May 31, 2016

Re: FirstLight Hydro Generating Company, Turners Falls Hydroelectric Project (FERC No. 1889) and Northfield Mountain Pumped Storage Project (FERC No. 2485).
Response to Stakeholder Requests for Study Modifications and/or New Studies Based on the Study Report and Meeting Summary

Attachment C to Study No. 3.3.6.
Figure 4.1-2A. Cabot Station, Station No. 1 and Turners Falls Dam Discharge (cfs) throughout the 2015 shad spawning survey period.

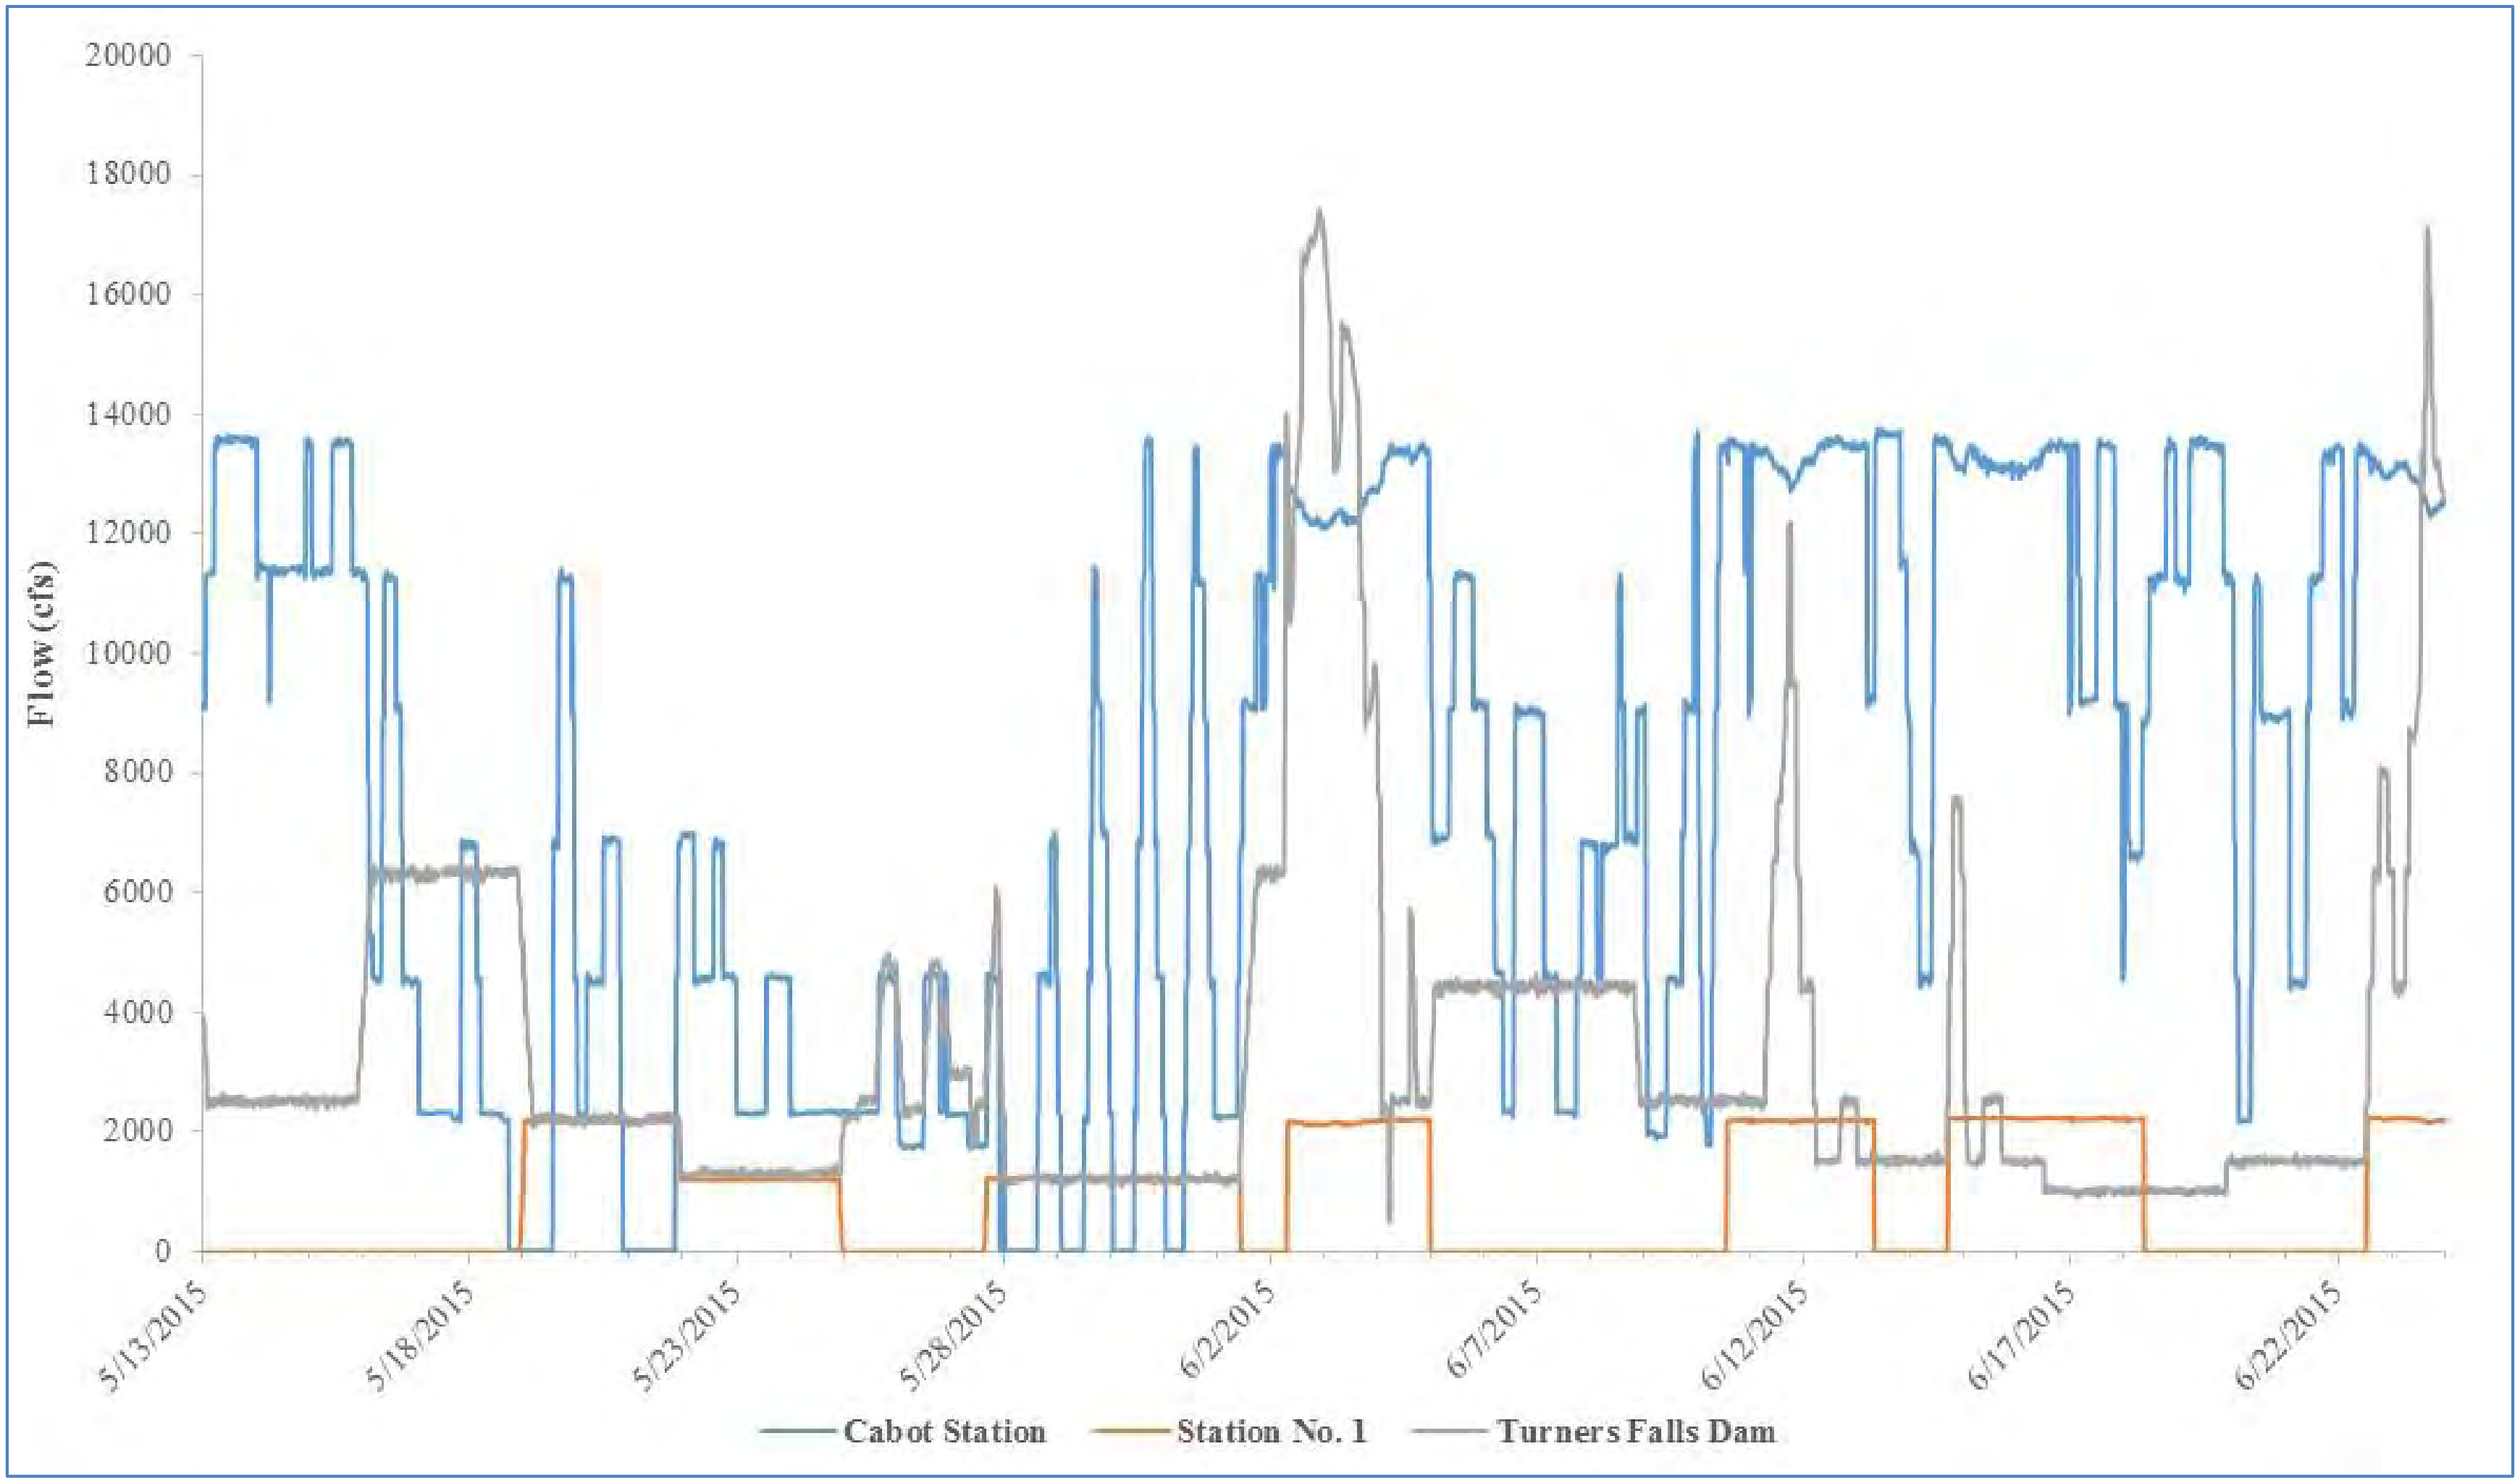
The splash count data should be presented and analyzed based on proportional change in discharge. The operational effects of relative change should be evaluated. It is unclear as written whether the individual-based models addressed this question. Models were developed to explore the effects of generation, river flow, etc., but proportional values were not reported or assessed.	The approved RSP did not specify data analysis methods for assessing proportional or relative changes and FL does not believe this additional analysis is warranted to meet study objectives as it was determined, through the Durbin-Watson test, that splash counts are dependent on time.
	Data should also be provided on Cabot unit discharge, Station #1 discharge, and spill flows over time during the study periods to understand project effects versus natural or Deerfield River flow effects, and the frequency and magnitude of flow fluctuations during the shad spawning period in a "typical" year.	Discharge data for Cabot Station, Station No. 1 and Turners Falls Dam during the 2015 survey period are attached as Study 3.3.6 Attachment C, Figure 4.1-2A.

Figure 4.1-2 clearly demonstrates rapidly fluctuating flows and numerous flow reversals based on 15-minute flow data (Zimmerman *et al*., 2010). However, the spawning observations were only analyzed by number of splashes and did not take into account the proportional changes in discharge from project operations within the period of observation. An analysis of the proportional change in river flow using the 15-minute USGS flow data at Montague as well as the proportional change in splash counts should be evaluated and discussed in the relicensing study.	See USFWS-7.
NMFS-7	Project Operation and Spawning Activity The report does not take into account the project operations that were occurring as part of Relicensing Study 3.3.2 whereby bypass flows were being altered throughout May and June. On March 8, 2016, a data analysis workshop was held for Relicensing Study 3.3.2. The color coded calendar indicating the bypass flows that occurred during the radio-telemetry study should be included in section 4.2.3 of the shad spawning study. We consider flows in the bypass reach, in addition to how many units at Cabot Station are operating, as an important project operation that was not considered, analyzed or explained in this report.	Minimum, maximum, and mean flow in the bypass reach is provided in Attachment A to Study No. 3.3.6 and reflects the flow manipulations that were being conducted in support of Study No. 3.3.2. Cabot Station, Station No. 1 and Turners Falls Dam Discharge (cfs) throughout the 2015 shad spawning survey period are included as Attachment C of Study 3.3.6.

Attachment D of Study No. 3.3.6.
Figure 4.3.1-1A: Histogram of log-transformed (ln(x)) splash counts before and after changes in Cabot Station generation.

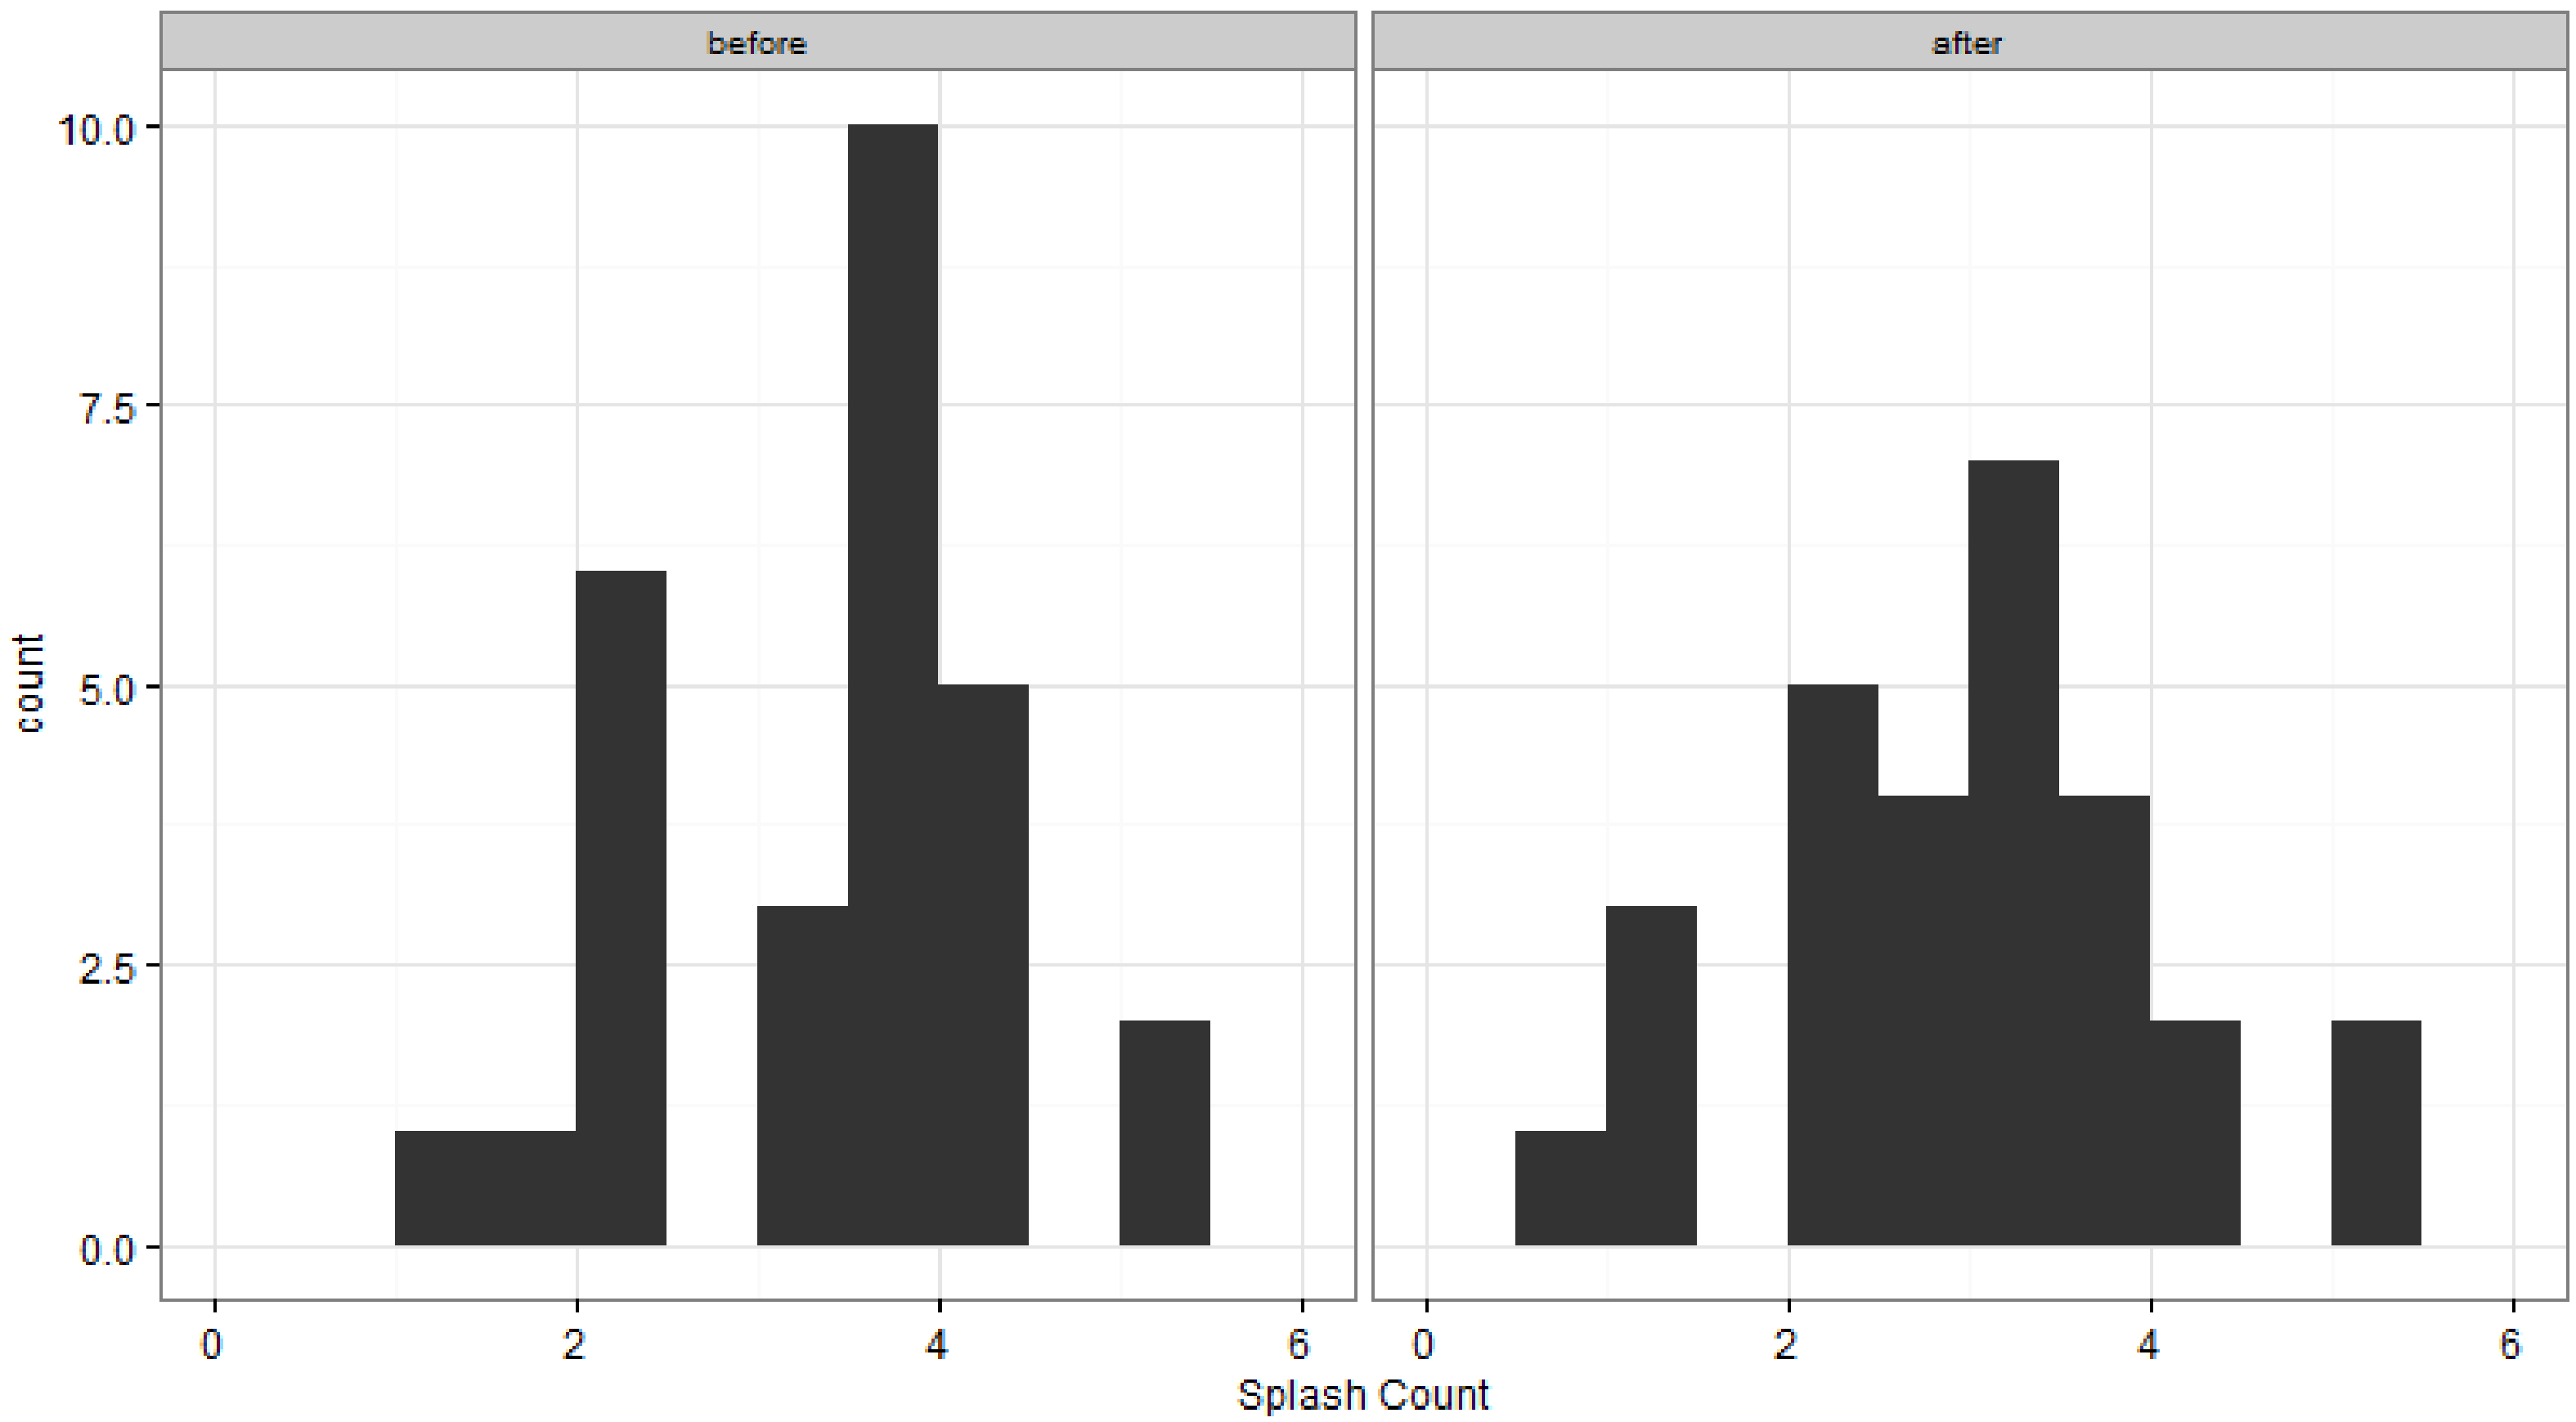
Commenter	Comment	Responses
	Spawning activity was assessed using splash counts, which was reported as average splash counts. Range and measures of variance should be reported, along with the mean splash counts.	Average was simply calculated as (Observer 1 count + Observer 2 count)/2. Attached as Study 3.3.6 Attachment B is Table 4.3-1A (a revision to Table 4.3-1 of the study report). It includes the actual before and after counts of both observers.
	Changes in project discharge affect water velocity. Data on changes in water velocity were not reported, but should be reported and analyzed for changes in splash count relative to direct and relative change in velocity.	
	Table 4.3-1 of the report provides flow data on the paired before/after unit change tests and identifies splash counts, Cabot generation before and after flow changes, time of before/after splash counts, changes in spawning area before and after unit changes and a single instantaneous USGS gage reading.	Velocity data were reported in Tables 4.2.1-2 and 4.2.2-1 and depicted in Figure 4.3.2.-2 of the report. As surface velocity measurements recorded by field crews near the river banks are not representative of the entire spawning area, the spatial relationship between water velocity and shad spawning will be more comprehensively assessed using data from the IFIM model. Because transects for the IFIM study were intentionally located to include shad spawning areas, the PHABSIM model output will be used to simulate shad spawning habitat suitability under a range of operating conditions and flows in the IFIM Study Report to be filed with FERC on October 14, 2016.

The net result of the above problems is that the study provides extremely limited information to evaluate the impacts of flow changes on shad spawning. The causes for the problems noted above are not clear, but appear to be two-fold: Failure to wait long enough after the generation change to conduct the "after" sample such that the flow change from Cabot Station had not yet stabilized at the shad spawning site being assessed. The fact that the May 28 splash counts noted above had the longest time between before and after samples (1 hour 22 minutes) and had "after" flows that were the closest to reflecting the change in generation supports this conclusion. Even with that time delay, however, flows during the "after" count did not fully reflect a full Cabot unit flow change. While the study plan proposed a delay between "before" and "after" counts of 20 minutes to one hour, the intention was to wait until flows stabilized. The basis for the 20 minutes to 1 hour proposal is unknown, but clearly that delay time was insufficient. The "after" count for all but one other generation change test was conducted 30 to 52 minutes after the generation change	These concerns are noted; however, the study was conducted in accordance with the approved RSP. All counts that occurred after the Cabot generation was manipulated occurred within the prescribed time limits set in the study plan (20 minutes to 1 hour). Counts were conducted by biologists on the river in a boat after dark. Besides the prescribed time limits, the biologists had to rely on their best judgment to determine when flows stabilized. In some cases, flows continued to change after the counts had commenced; however the biologists made real time decisions without the retrospection of being able to look at future gage data. Considering the influence of time on daily spawning activity (counts decrease with time since sunset), increasing the duration between before and after counts would not help to discern project effects.
